Kims Corporation Ltd.

16, Sutar Noardda, Arapara, Savar
(23.850058, 90.251219)
03 May 2014

Observations

Observed high loading

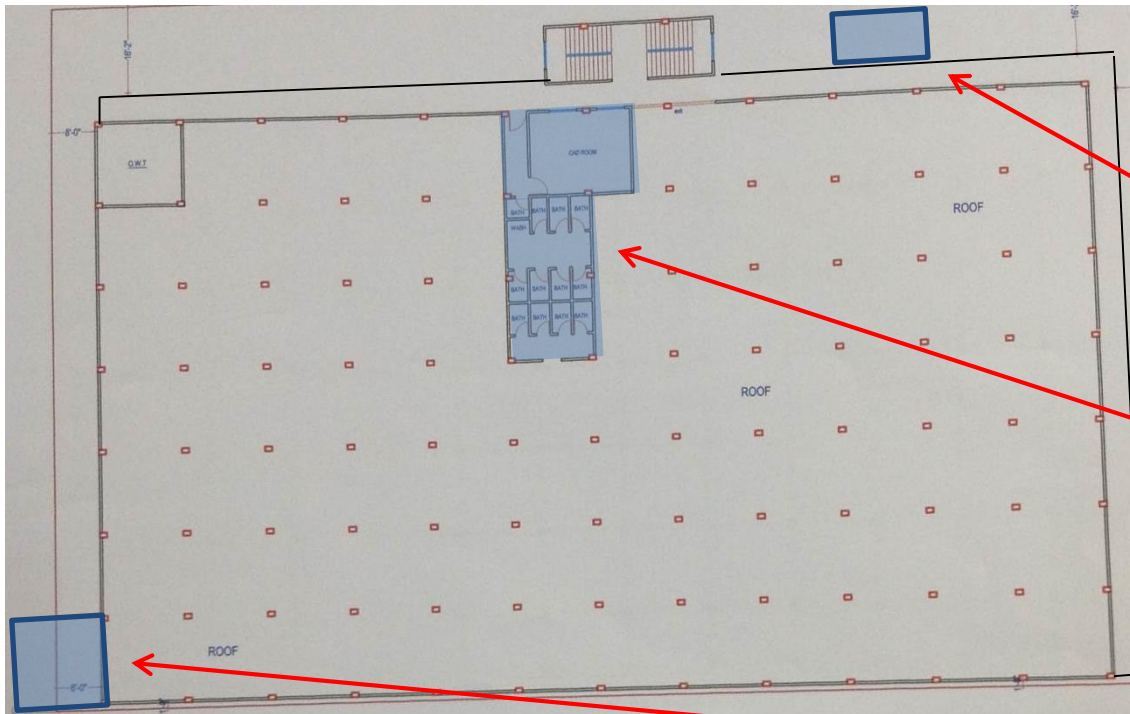
**200mm build-up in
toilet area on 1st and
2nd floor toilet areas**

**Concrete water
tank at roof level**

**Heavily loaded
columns**

Documentation: highlighted areas not documented on structural drawings

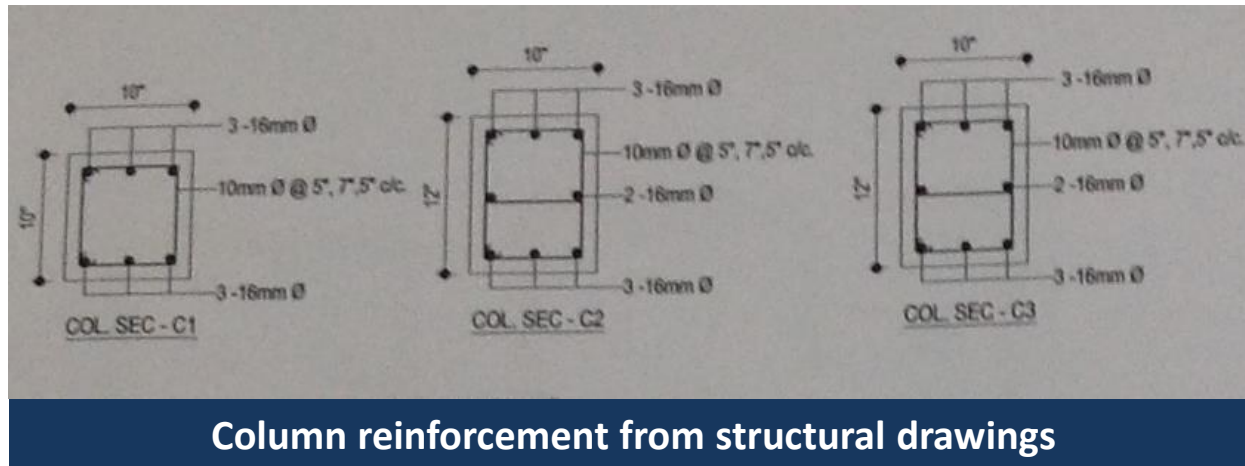
- Steel staircase located adjacent to the primary stair well not present on any drawings.
- CAD room and toilet block not on the original structural drawings.
- Stair well leading to the mosque room located on the southern side of the building not present on either the structural or as-built drawings.
